EPC STORMWATER REVIEW COMMENTS
IN ORANGE BOXES WITH BLACK TEXT

Early Grading Permit - Final Drainage Report

Overlook at Homestead Subdivision Filing No. 1 El Paso County, Colorado

Worksheet for B6-1

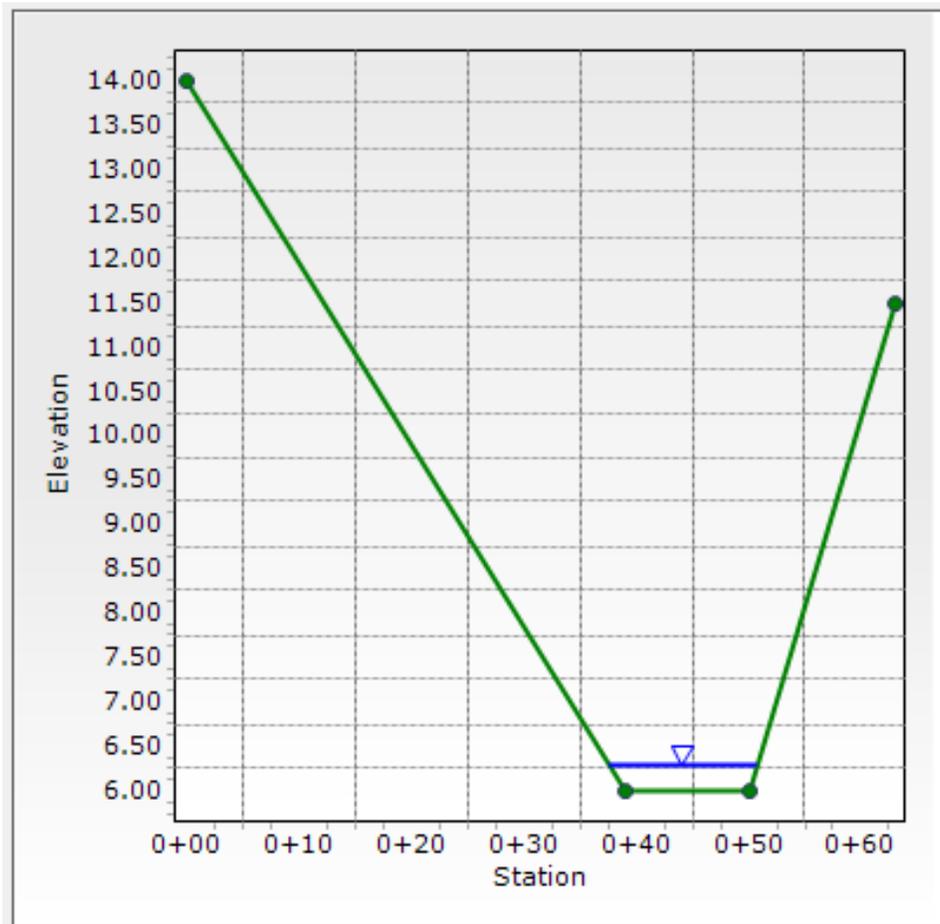
Please provide erosion protection for the channel B6-1 as velocity is above the standard velocity in DCM V1, chapter 10, table 10-4. Please verify all channels and identify erosion protection needed.

Discussion regarding channels and erosion protection has been added to report. TRM now called out on channel analysis.

SHEET
EX-1

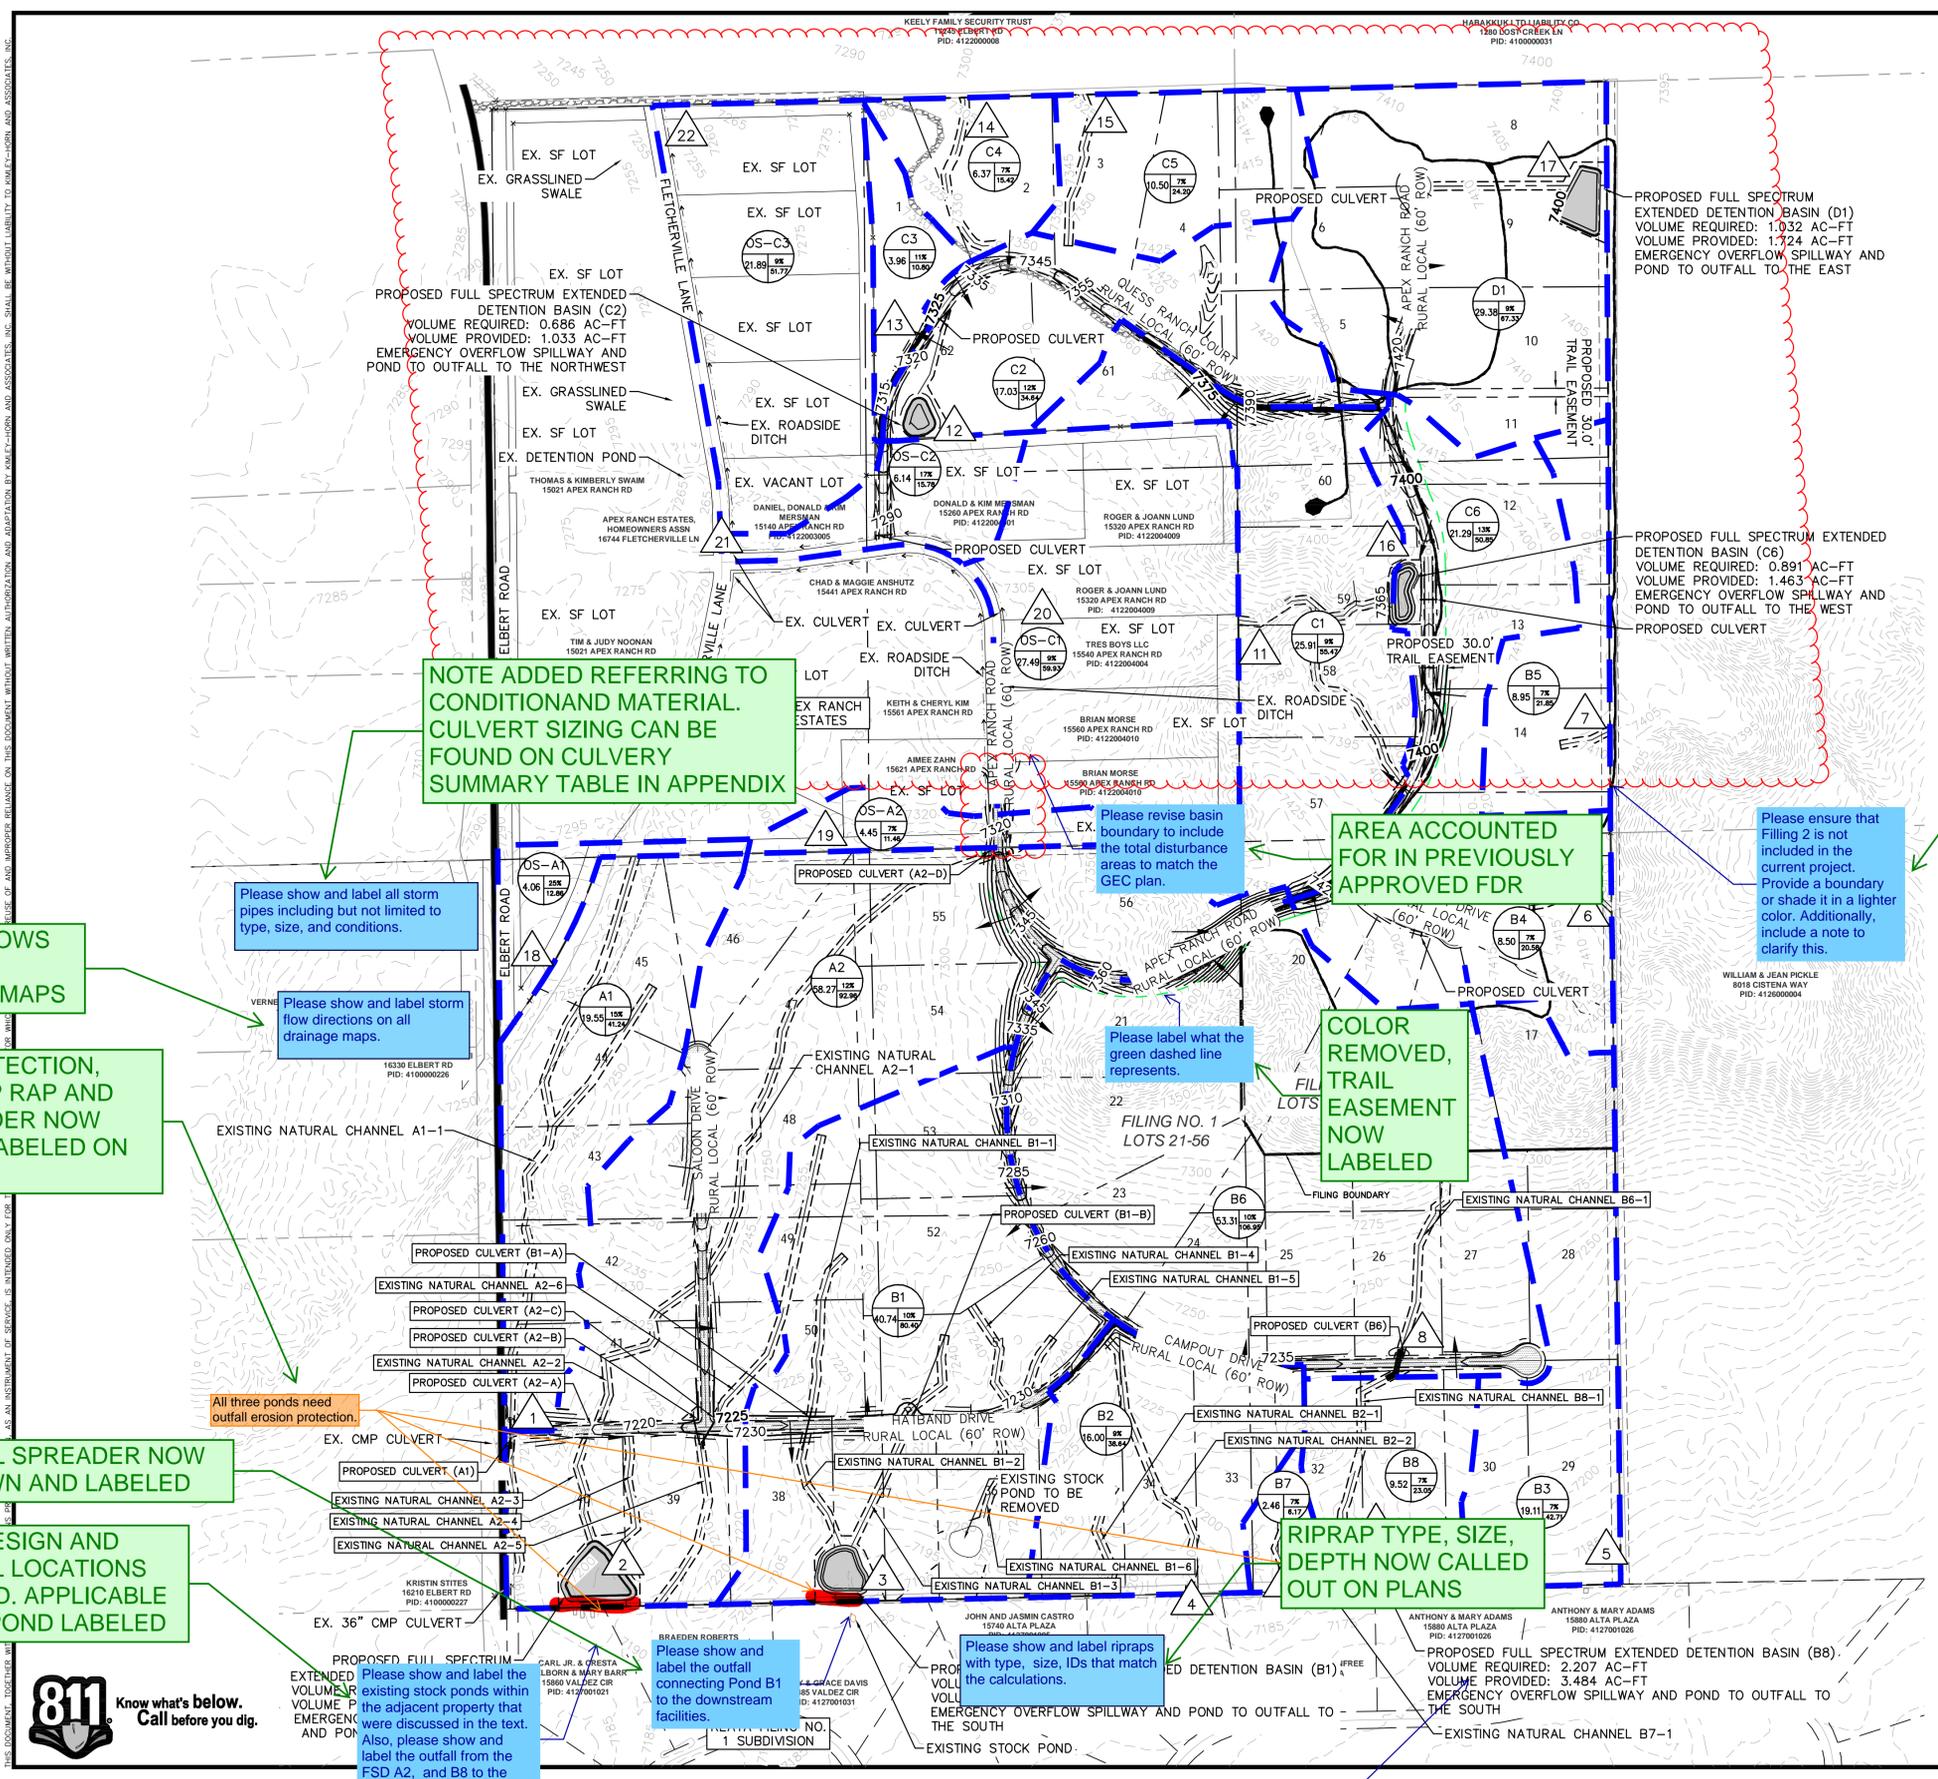
It appears that all channels are existing. Please clarify. If they are existing, please show and label them on the existing drainage map.

Please show and label the outfall west of Elbert that was mentioned in the existing sub-basin A1. This comment also applies to the proposed drainage map.

Existing drainage channels now shown and called out in existing conditions map.

OVERLOOK FILING NO. 1
 EL PASO COUNTY, COLORADO
 PRELIMINARY DESIGN PLANS
 PROPOSED DRAINAGE MAP

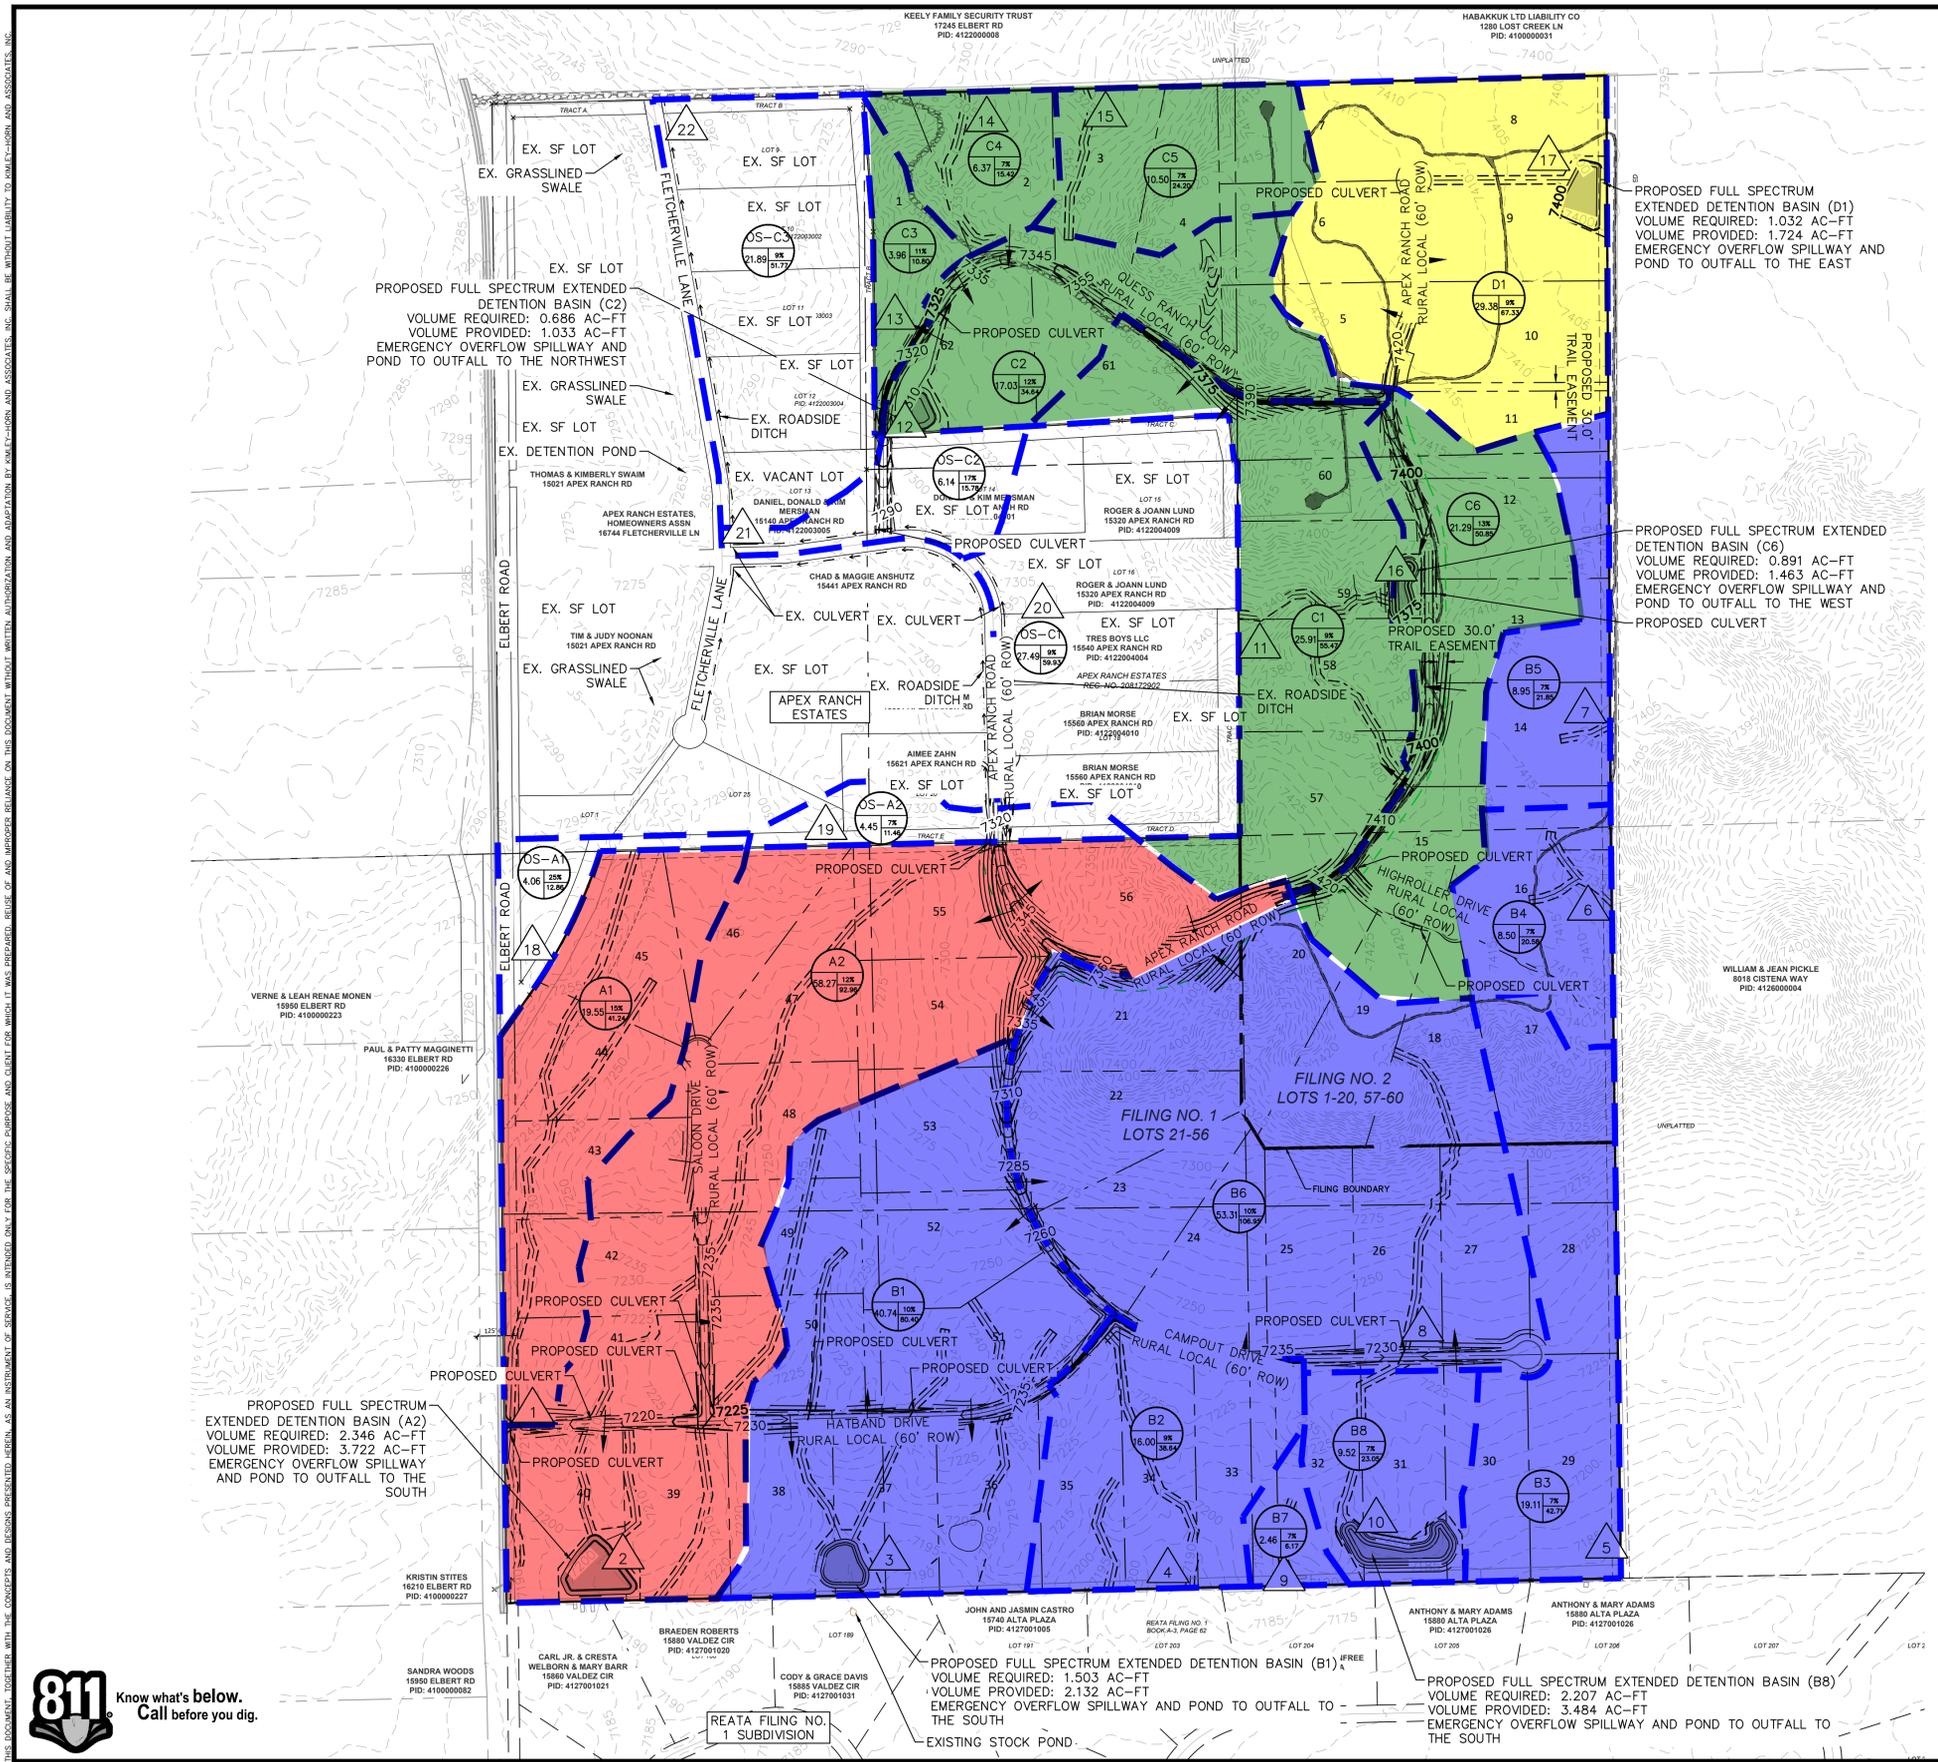
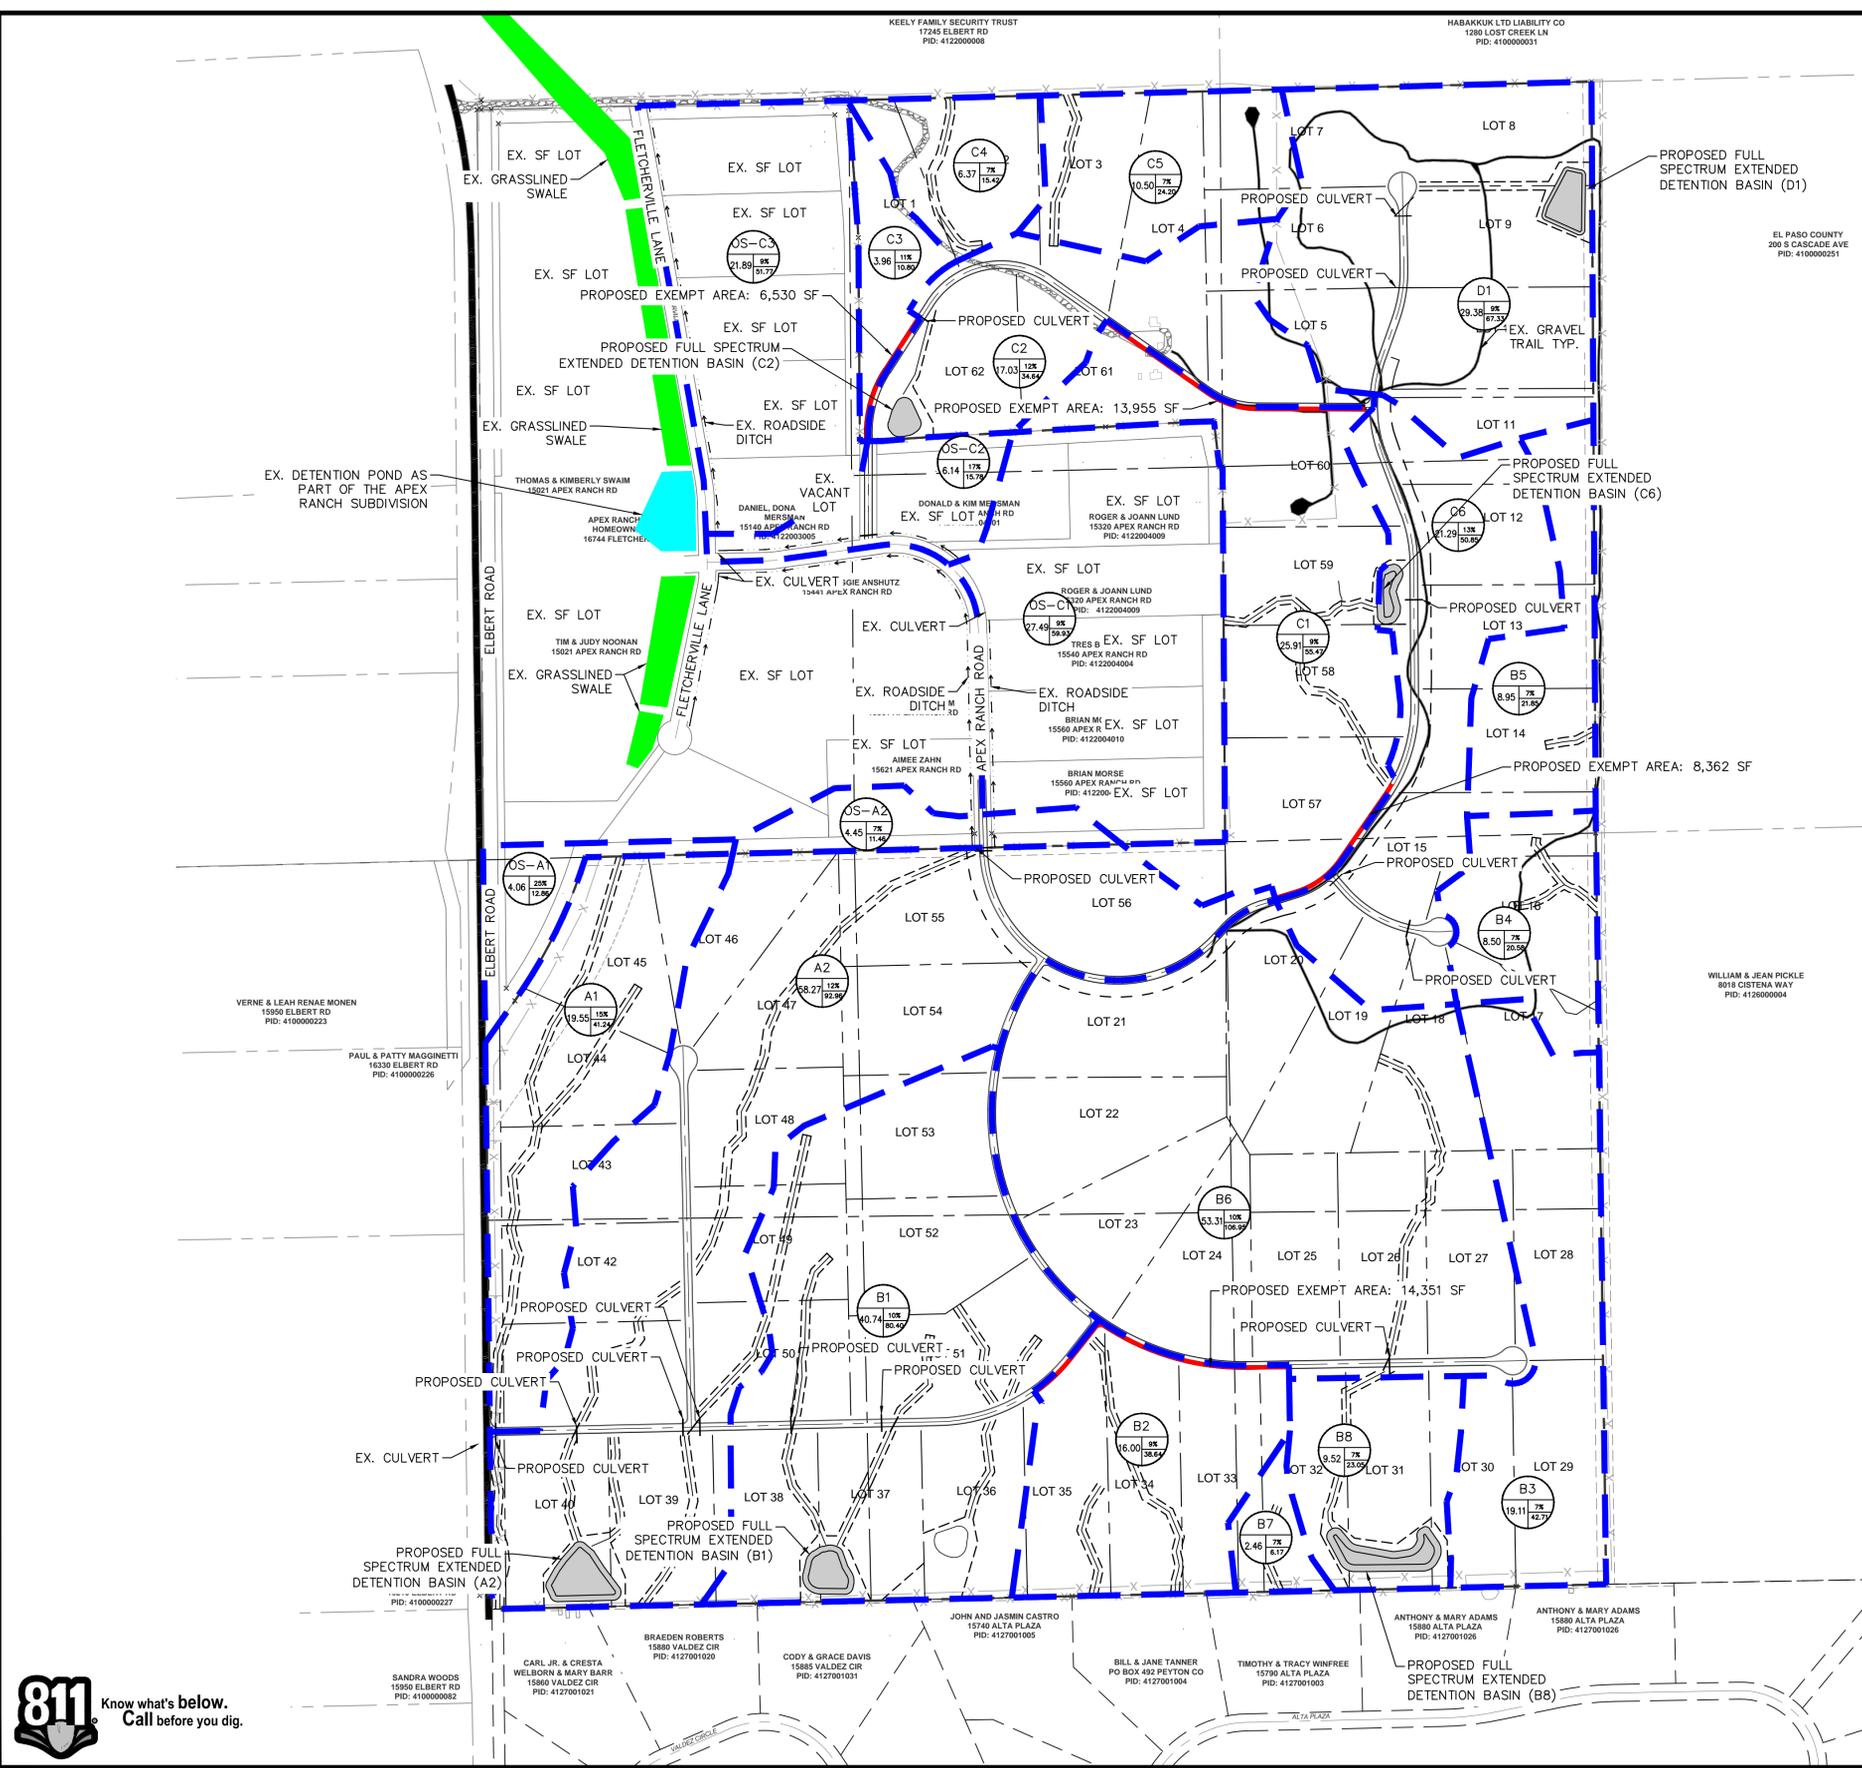
Note as mentioned in the PRELIM Plan PDR all temp and permanent ponds must be located back from the property boundaries to accommodate the outlets structures necessary and emergency overflows. Ensure next submittal shows these details.

Please label three pond as temporary ponds to match the text discussion and grading erosion control plan.

Please show and label all storm pipes including but not limited to type, size, and conditions.

Please show and label storm flow directions on all drainage maps.

Please revise basin boundary to include the total disturbance areas to match the GEC plan.

Please ensure that Filing 2 is not included in the current project. Provide a boundary or shade it in a lighter color. Additionally, include a note to clarify this.

FLOW ARROWS ADDED TO DRAINAGE MAPS

POND LABELS UPDATED TO MATCH GEC PLANS
